TECHNISCHE INFORMATION NR. SI 36-109

SERVICE INFORMATION NO. SI 36-109

Rotax Service Bulletin Nr. SB-912-070R1 und SB-914-052R1

Inspection and/or replacement of the valve push-rod assy., rocker arm left and rocker arm right for ROTAX® Engine Type 912 i, 912 and 914 (Series)

Fig. 1
Visual inspection

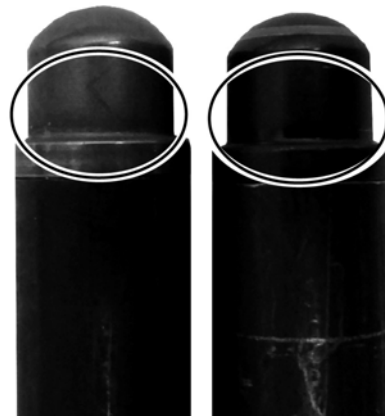
Perform visual inspection of all push-rod ball sockets on all cylinder.

Check for color. See Fig. 1.

Color	Evaluation
Silver surface	Valve push-rod is OK. No further action required for this valve push-rod.
Black surface	Valve push-rod is NOT OK. See section. 3.1.3) Replacement of affected parts.

GOOD
(silver color)

BAD
(black color)

Fig. 2

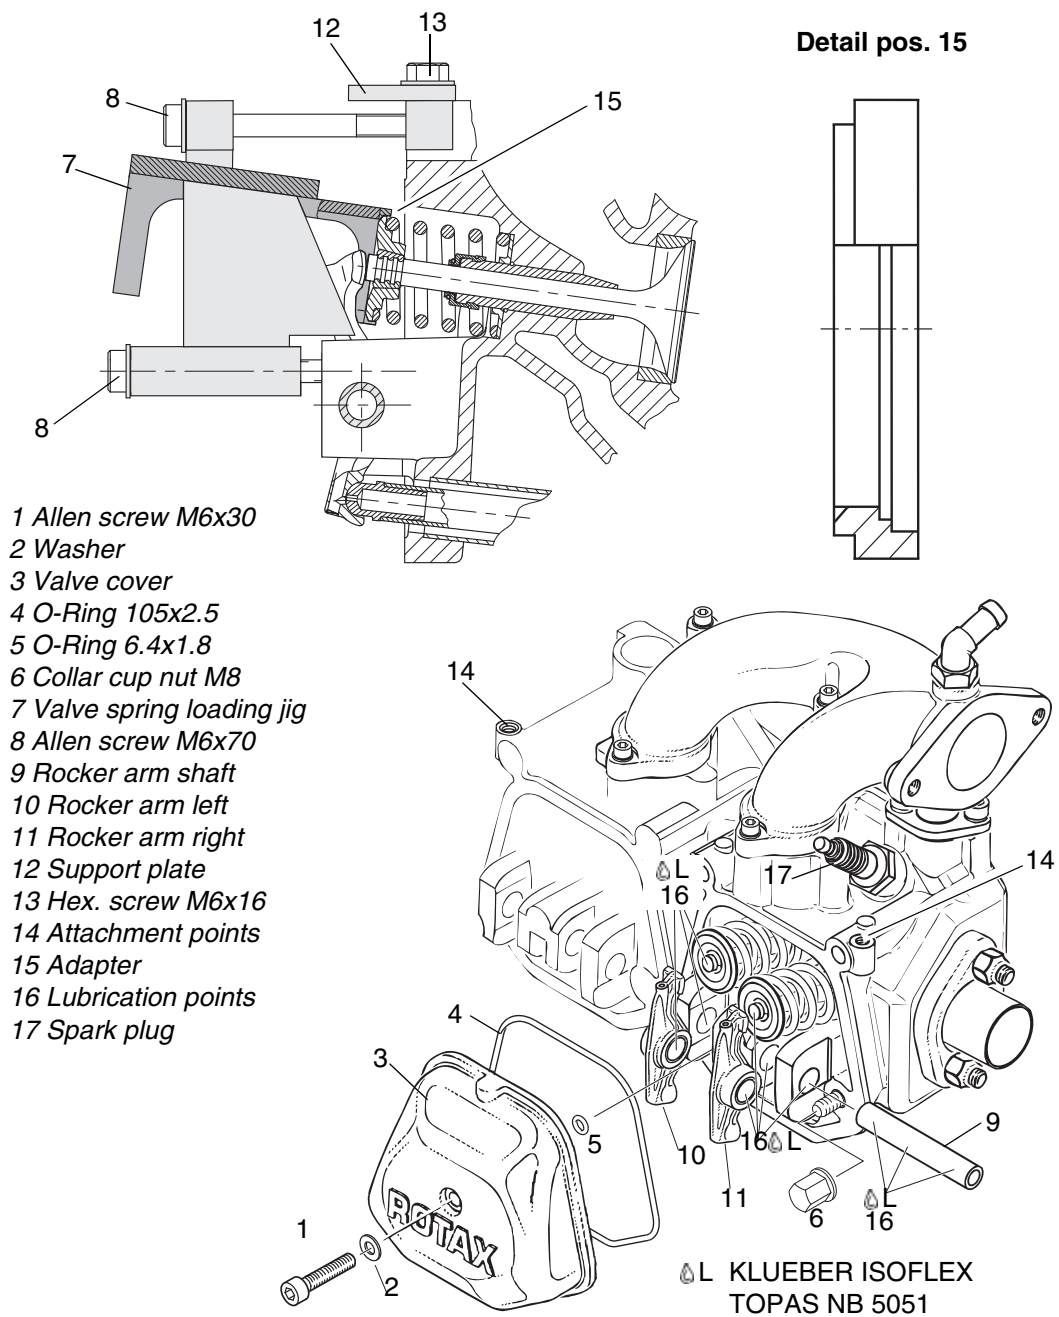
See Fig. 2.

Step	Procedure
1	Loosen Allen screw (1) M6x30 with washer (2) from valve cover (3), and remove it together with large and small O-rings (4) and (5).

See [Fig. 2](#) and [Fig. 3](#).

Step	Procedure
3	Attach the support plate (12) to the valve spring loading jig part no. 877387 (7) with 2 hex. screws (13) M6x16 at the attachment points (14) on the cylinder heads.
4	Put adapters (15) on the valve spring loading jig.
5	Attach the valve spring loading jig on cylinder head and support plate with 2 Allen screws (8) M6x70 and depress both valves with 3 turns.

Step	Procedure
1	Clean the sealing surface of cylinder head and valve cover with a suitable lint-free cloth or equivalent.
2	Insert new O-ring (4) 105x2.5 and O-ring (5) 6.4x1.8 into the valve cover (3).
3	Fit valve cover.

Step	Procedure
4	Tighten the new Allen screw (1) M6x30 with washer (2) to 10 Nm (89 in.lb).

Fig. 3

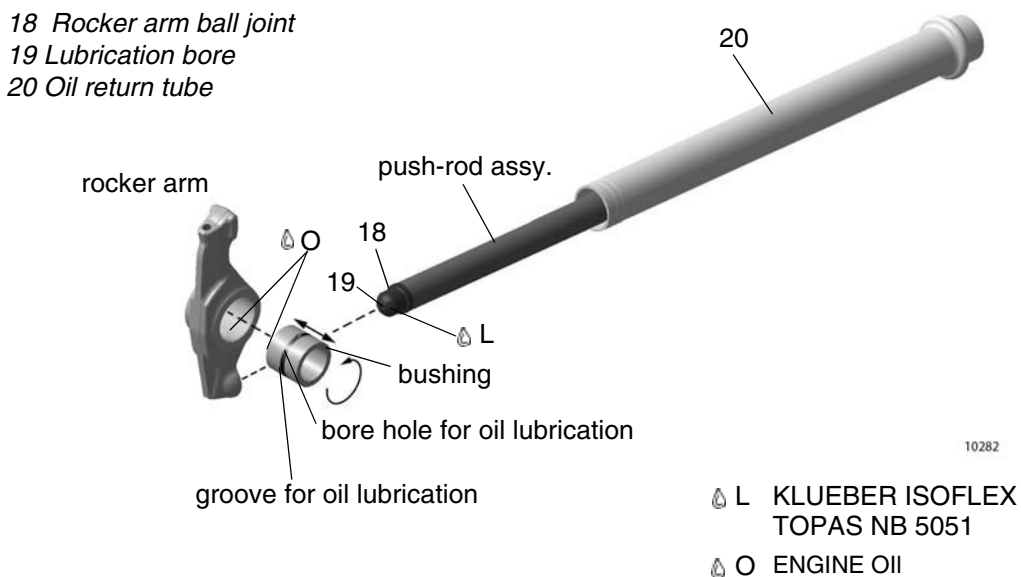
Step	Procedure
6	This will relieve the pressure from both hydraulic tappets. Now the rocker arm shaft (9) may be easily pulled out. Lift out both rocker arms (10) and (11).
7	Replace only affected parts as per section 2.3 . See also Fig. 3 .
8	Apply KLÜBER ISOFLEX TOPAS NB 5051 (16) on both push-rod ball sockets and contact areas of rocker arm and slide push-rod into the oil return tube (20).
9	Check bushing and rocker arm shaft according to latest Maintenance Manual Heavy.
10	Put oil on the rocker arm bushing.
11	Place rocker arm left (10) and rocker arm right (11) in cylinder head, apply KLÜBER ISOFLEX TOPAS NB 5051 (16) on rocker arm shaft (9) and insert it into its bearing support.
12	Loosen valve spring loading jig and support plate.
13	When removing the valve spring loading jig, make sure the adapter rings (15) do not jam on the valve spring retainer.
14	NOTE: Only when you have an Criterion B) Spare parts affected engine and only if engine is equipped with collar cap nuts M8 wrench size 13: Mount collar cap nut (6) according to latest Maintenance Manual Heavy or SI-912-025/SI-914-026/SI-912 i-010.
